Artessa – Applicant Response Letter
January 8, 2025

11/20/24 City Issued 3rd Review Comment Letter

RE: **2-ZN-2024**

Artessa

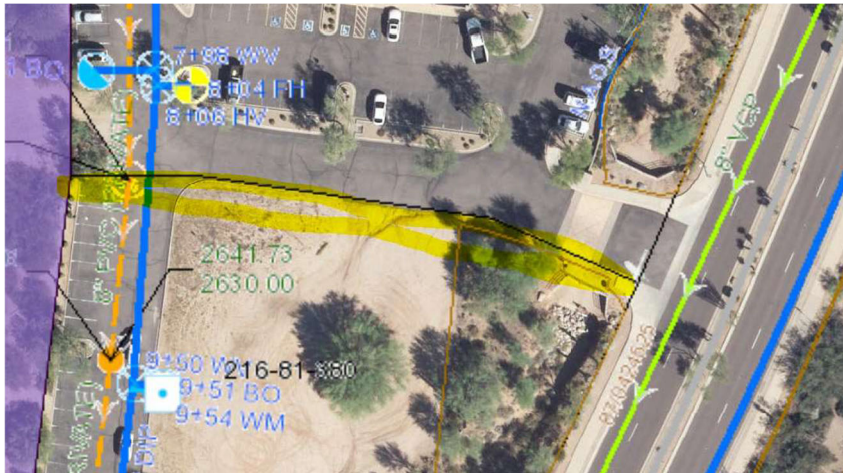
9. 1st- DSPM 2-1.309: REFUSE. Provide a refuse plan meeting all city refuse requirement given in DSPM 2-1.309.

2nd- Not addressed properly. Understood regarding 67 units but the 2 double enclosure placements do not comply with the requirement to provide a one direction pick-up route through project. As

proposed, the truck would have to go in one way, exit to commercial area, turn themselves around, and go back in the way they came out to pick up the other enclosure. 1 double enclosure housing a 4 cubic yard vertical compactor and a refuse container could suffice for this development, else relocate one of the enclosures so it can be picked up from the same direction as the other.

3rd- Not addressed. Refuse plan does not demonstrate compliance for a 40' truck's 45' truck turning radius into and out of the proposed refuse enclosures, nor that the refuse truck does not need to back track to serve the multiple containers proposed.

- a. Please note that 90 dwelling units necessitates a 6 cubic yard minimum horizontal or vertical compactor. Please make sure to accommodate in refuse plan accordingly, specifically stating the compactor to be used to assure appropriate site space has been provided for it.
- b. An emergency and services access easement along the refuse service route to and from city streets, crossing parcels boundaries, will be required. Update refuse plan accordingly.

Response: The refuse truck and recycle truck turning radius has been added showing compliance with head on access to each 4-yard container. The recycle enclosure has been relocated to accommodate a direct head on access to the enclosure. Calculations for the 67-unit residences have been added for the required (2) 4-yard containers for refuse and (2) 4-yard containers for recycle. Refer to A1.13 REFUSE AND RECYCLE PLAN.

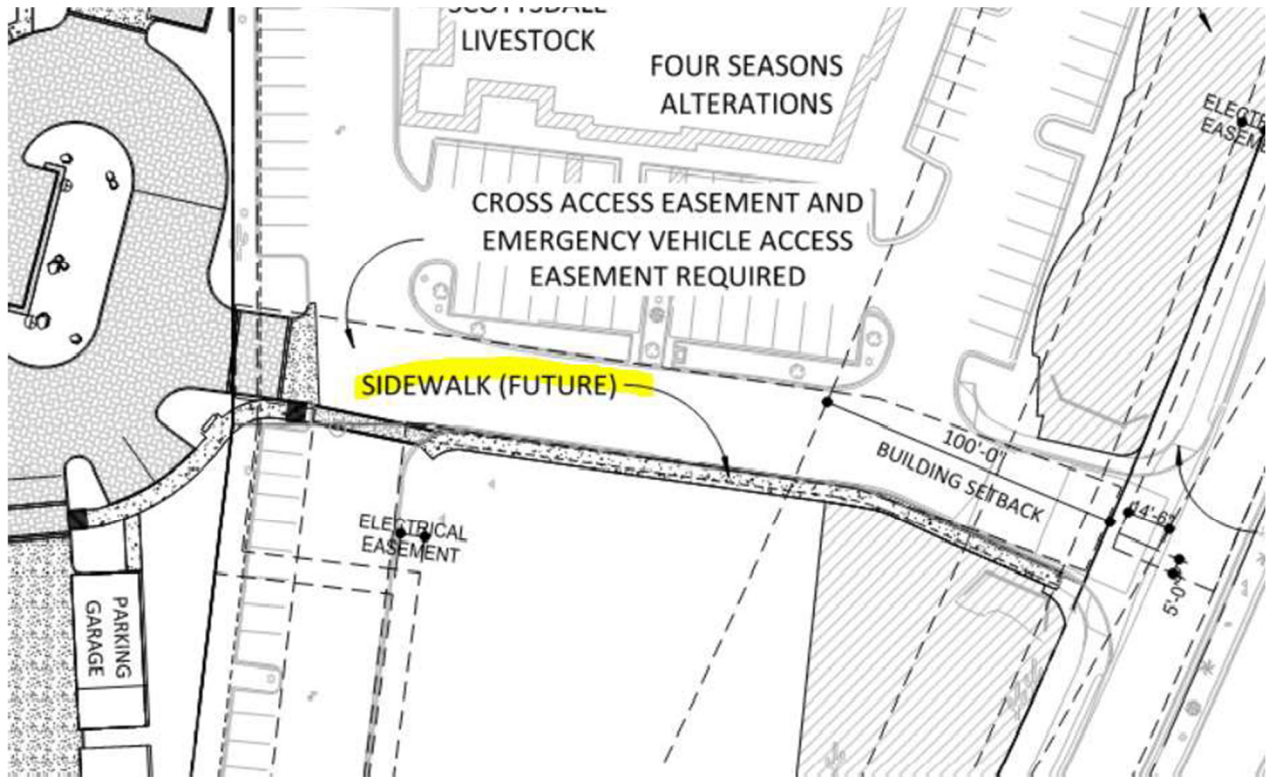
10. 1st- DSPM 2-1.310: A 6' wide accessible pedestrian route from the main entry of the development to each rezoning area abutting public street is required.

2nd- Please add construction of 6' sidewalk to N Alma School as a scope of this project (currently not depicted within provided preliminary G+D). Missing sidewalk is located here, existing parking stalls in conflict with proposed sidewalk connection are to be modified to accommodate this pedestrian connection: Addressed.

3rd-NO LONGER ADDRESSED.

This is not a sidewalk future. This is a sidewalk needed to provide with this project, update their site plan accordingly, SIDEWALK WITH THIS PROJECT:

Response: The note has been revised to show a 6' sidewalk. Refer to A1.2 OVERALL SITE PLAN.

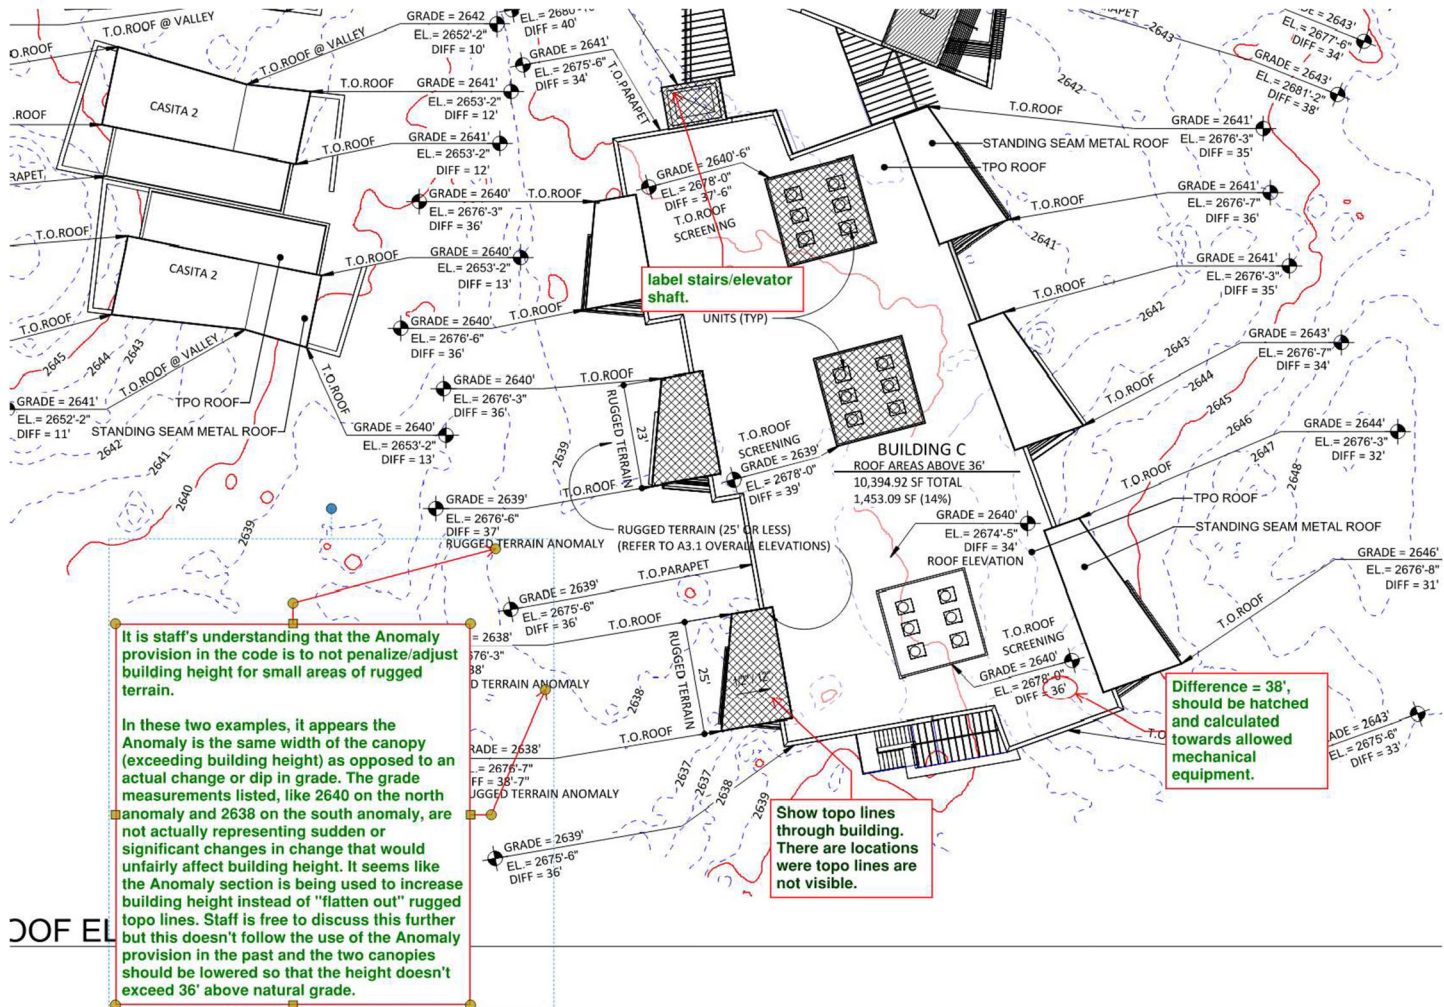
18. Please address the comments on the roof plan, below.

Response: The roof plan has been revised to show topo lines through building, updated heights at mechanical screening, identification of elevators and stairs, and clarifications on the two rugged terrain anomalies. Refer to A4.1 OVERALL ROOF PLAN.
